KEPHART DAM
NDS I.D. No. PA-00447
PENNDER I.D. No. 14-89

PHASE I INSPECTION REPORT
NATIONAL DAM INSPECTION PROGRAM

Distribution Unlimited
Approved for Public Release
Contract No. DACW31-79-C-0013

MARCH 1979

EMERGENCY SPILLWAY CROSS-SECTION (FIELD MEASURED)
 SCALE 1 in = 20 ft

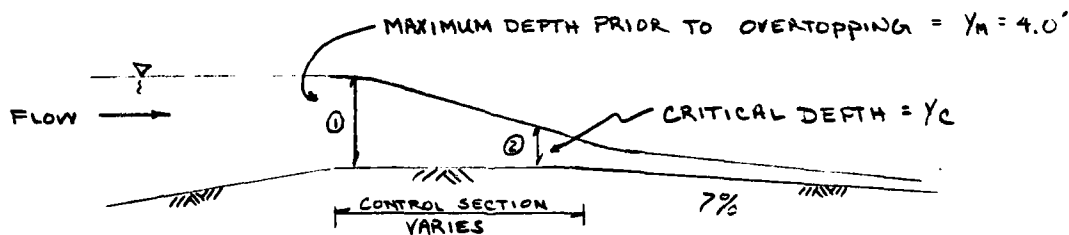
2. Emergency Spillway. The visual inspection of the emergency spillway revealed that it was unobstructed and in good condition. The calculations indicate that the emergency spillway design was prepared based on a crest width of 40 feet. Field measurements indicate that the actual width is approximately 60 feet.

NOTE: ALTHOUGH THE DESIGN EMERGENCY SPILLWAY RATING CURVE IS ALSO AVAILABLE, IT IS BASED ON A SECTION WITH A BOTTOM WIDTH OF 40 FT AND A CREST ELEVATION AT 1869.5 FT. FIELD MEASUREMENTS INDICATE THAT THE ACTUAL SECTION HAS A BOTTOM WIDTH OF ABOUT 60 FT AND A CREST ELEVATION AT ABOUT 1870 FT. THE FOLLOWING IS BASED ON THESE FIELD MEASUREMENTS AND THE GIVEN RATING CURVE HAS BEEN DISCARDED.

FIGURE 1 - KEPHART DAM
GENERAL PLAN
FIELD INSPECTION NOTES

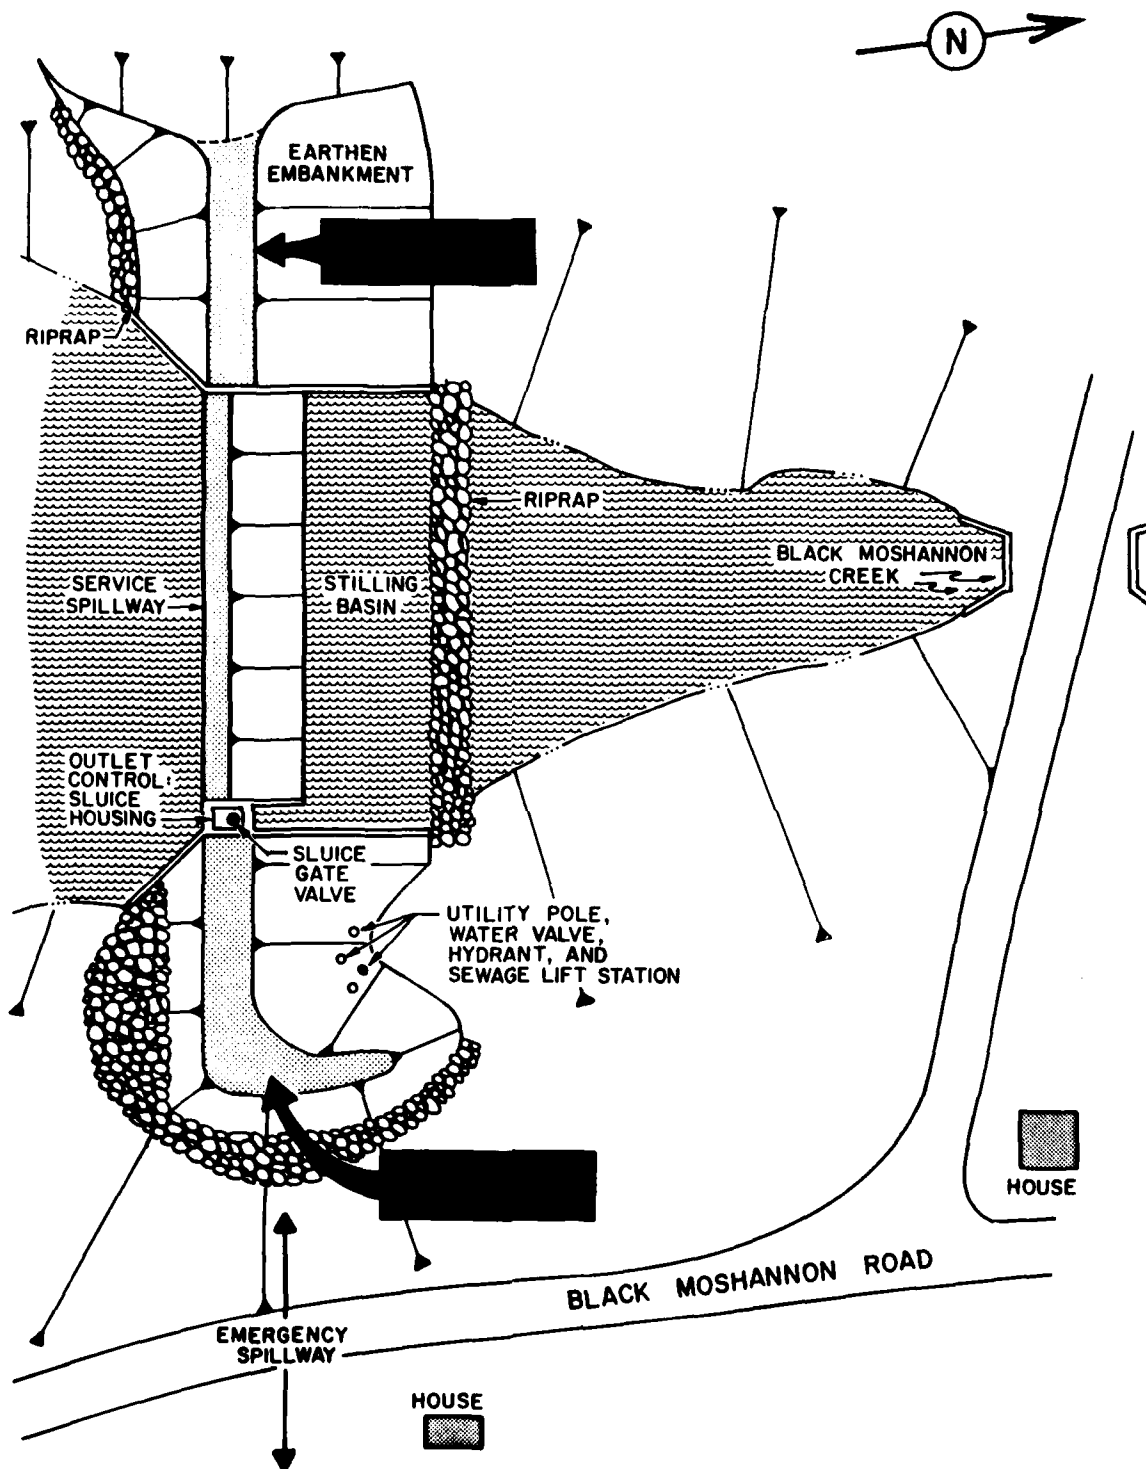
Both the upstream and downstream faces of the dam are covered with crown vetch. Minor settlement was noted on the dam crest along both sides of the spillway. The maximum settlement noted at the time of inspection was approximately 0.6 feet below the designed crest elevation of 1874.0 feet.

Observations made during the visual inspection indicate that the overall condition of the facility is good. Minor settlement of the embankment crest was noted. The crest should be surveyed and low spots filled in.

- (a) Have the embankment crest surveyed and infill any low spots to restore the embankment section to its design elevation (1874.0).
- (b) Extend the riprap protection to the top of the dam along the emergency spillway-embankment junction to provide slope protection in the event the emergency spillway should discharge at or near full capacity.
- (c) Develop a warning system to provide for the notification of temporary downstream residents should hazardous conditions develop.
